COPPERSTRING EIS

Attachment F - Vegetation Clearing Works plans

Dajarra Road Substation to Selwyn Substation

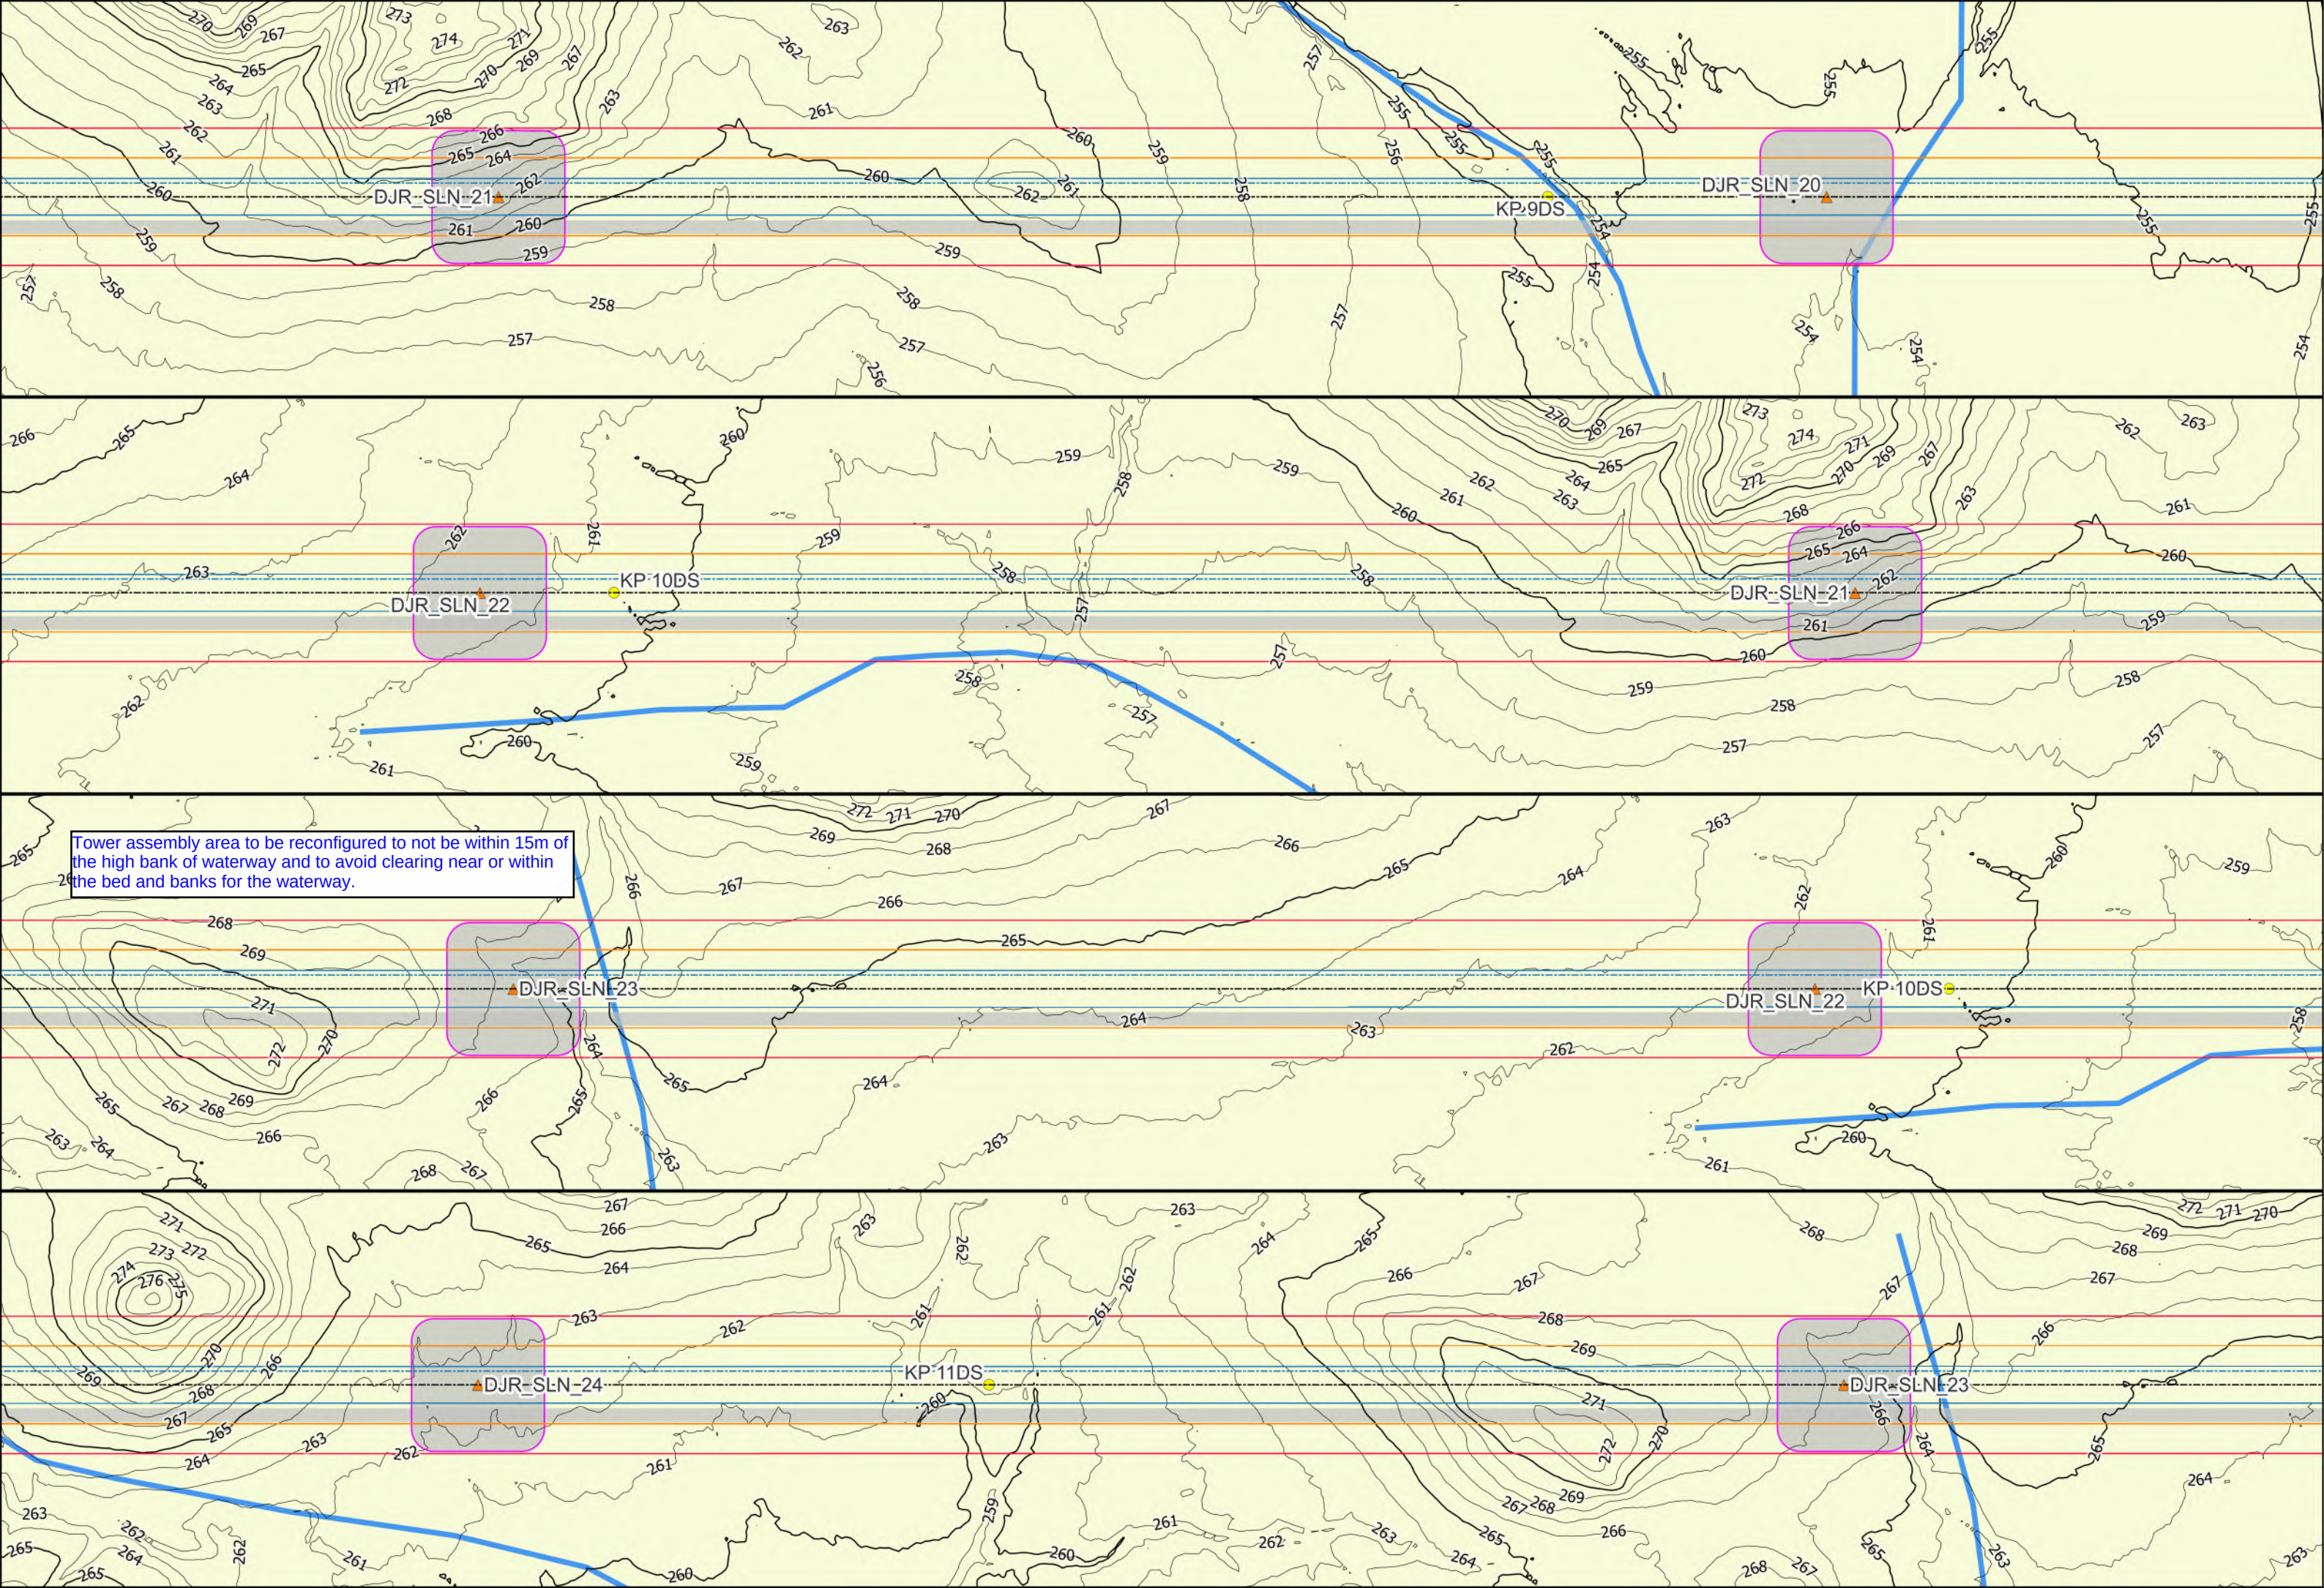
Tower assembly area to be reconfigured to not be within 15m of the high bank of waterway and to avoid clearing near or within the bed and banks for the waterway.

DJR_SLN-23

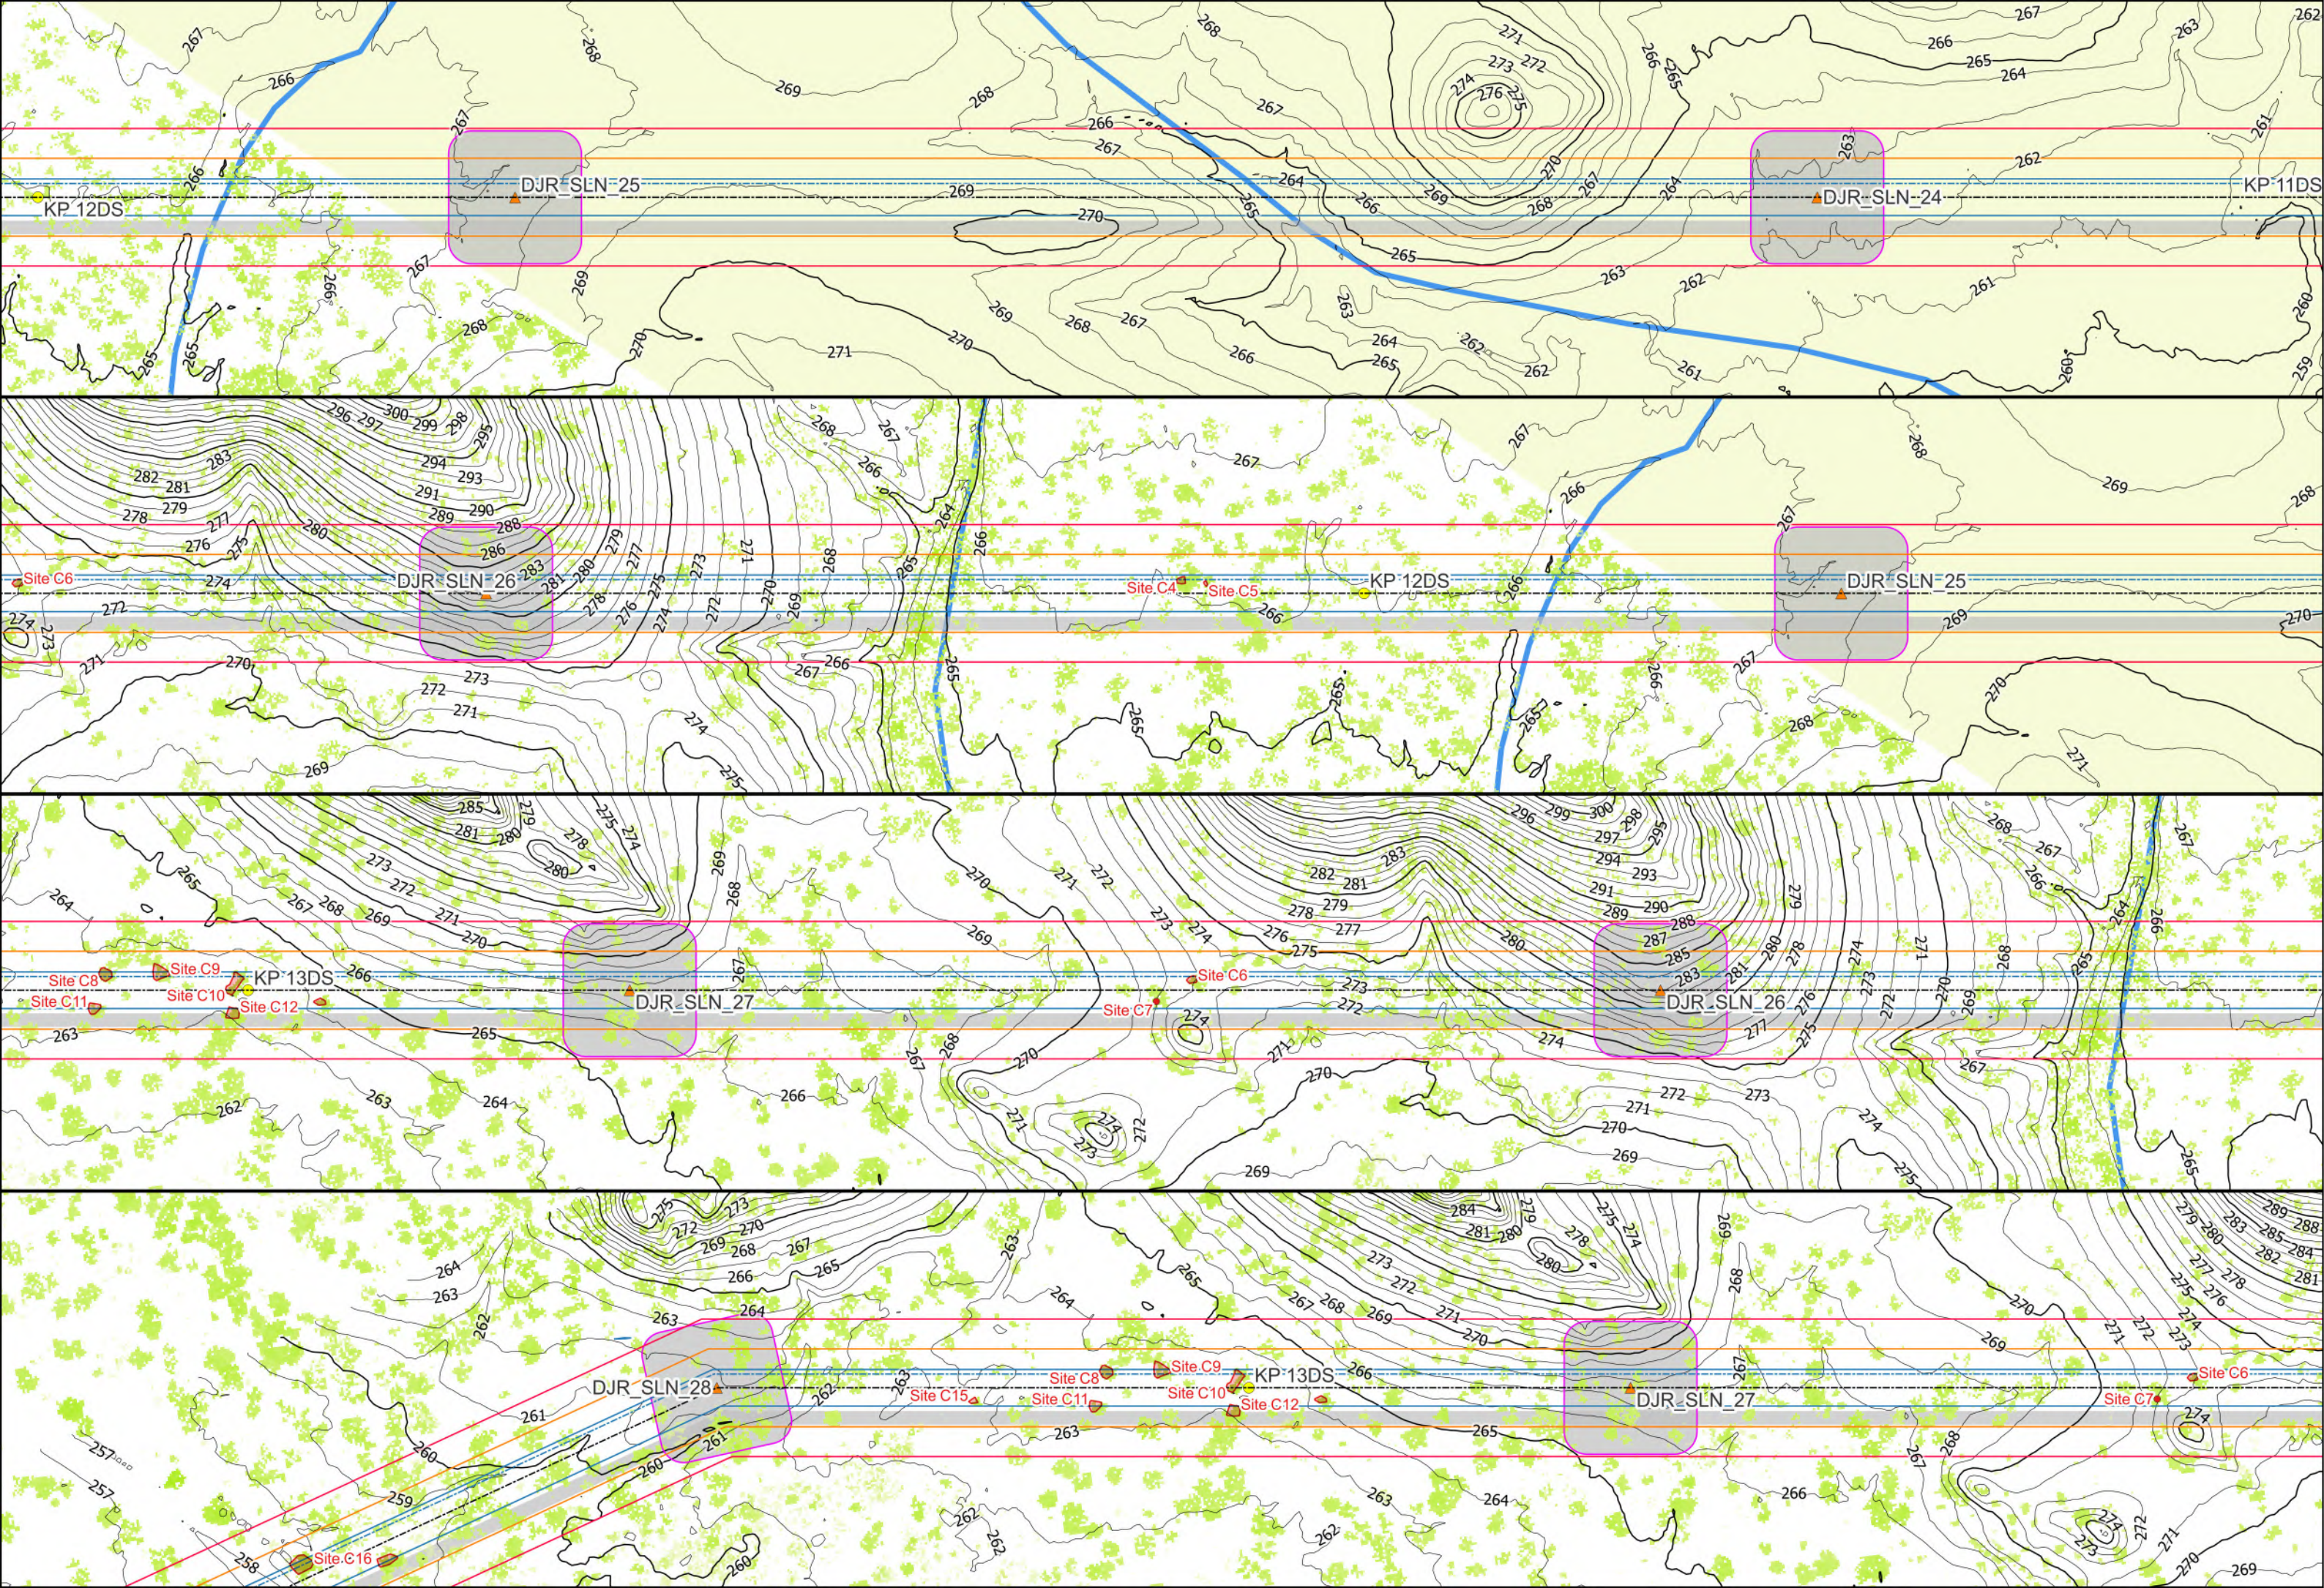
Tower assembly area to be reconfigured to not be within 15m of the high bank of waterway and to avoid clearing near or within the bed and banks for the waterway.

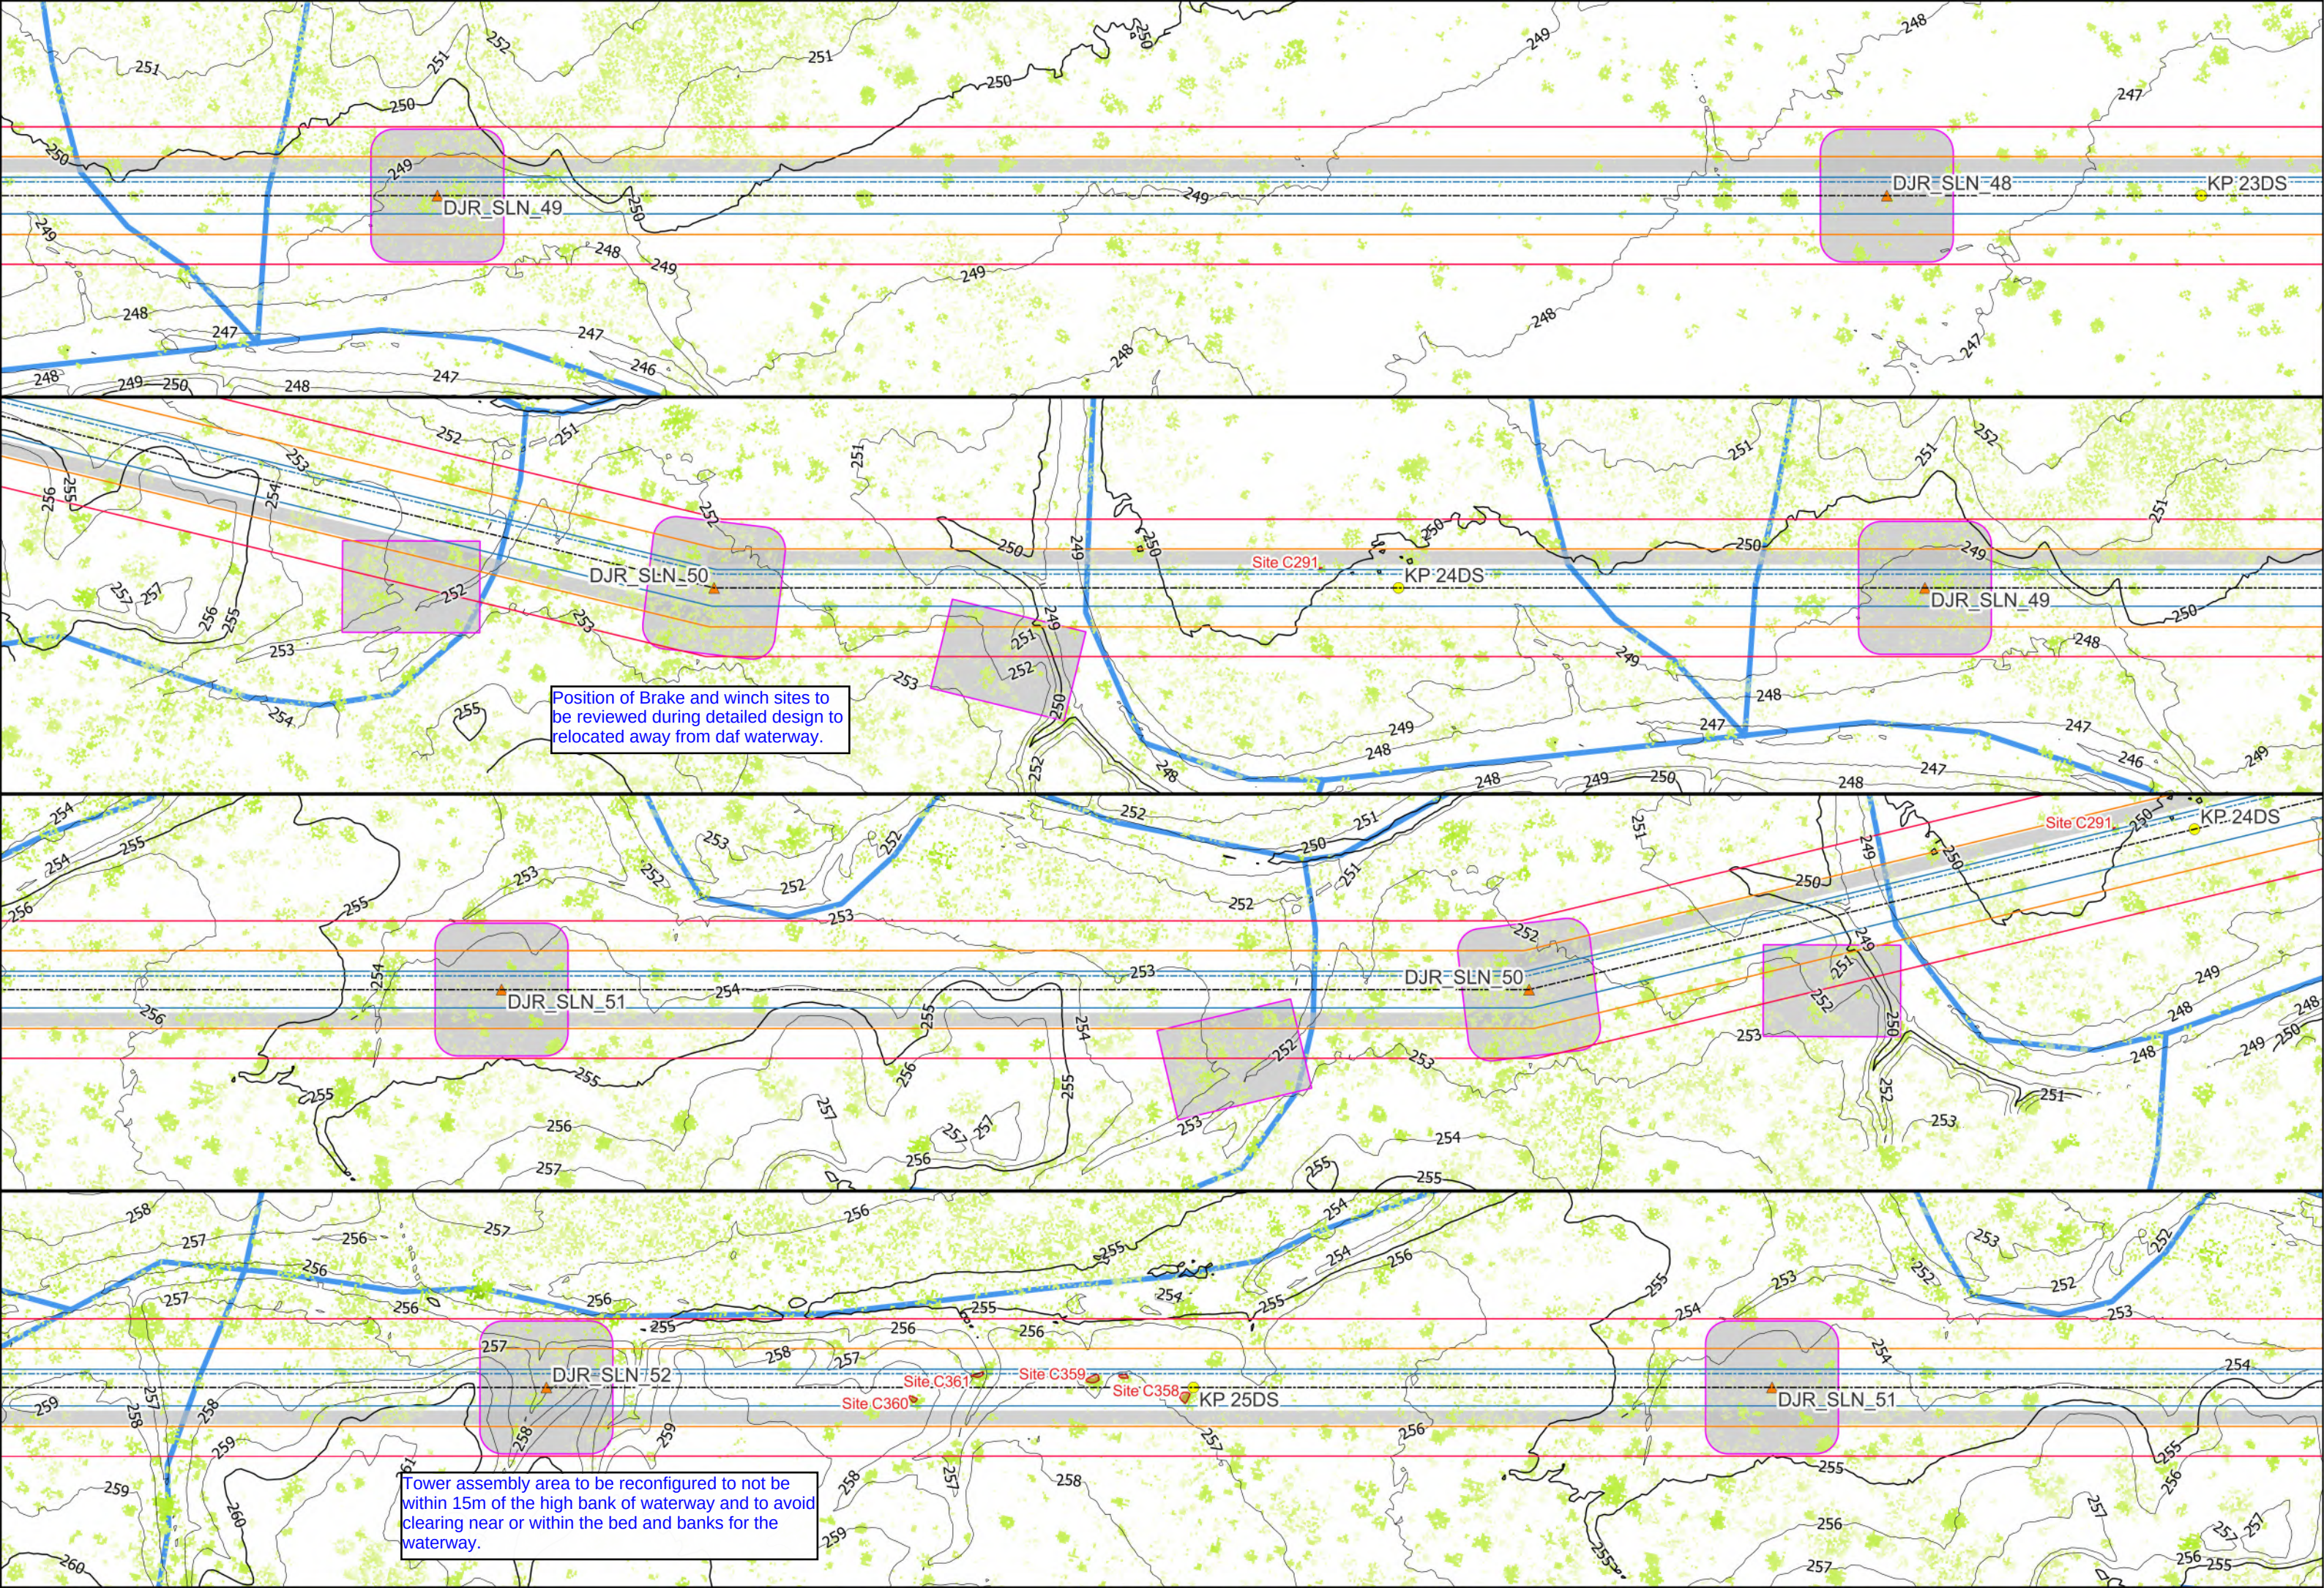
Tower assembly area to be reconfigured to not be within 15m of the high bank of waterway and to avoid clearing near or within the bed and banks for the waterway.

Position of Brake and winch sites to be reviewed during detailed design to be relocated away from daf waterway.
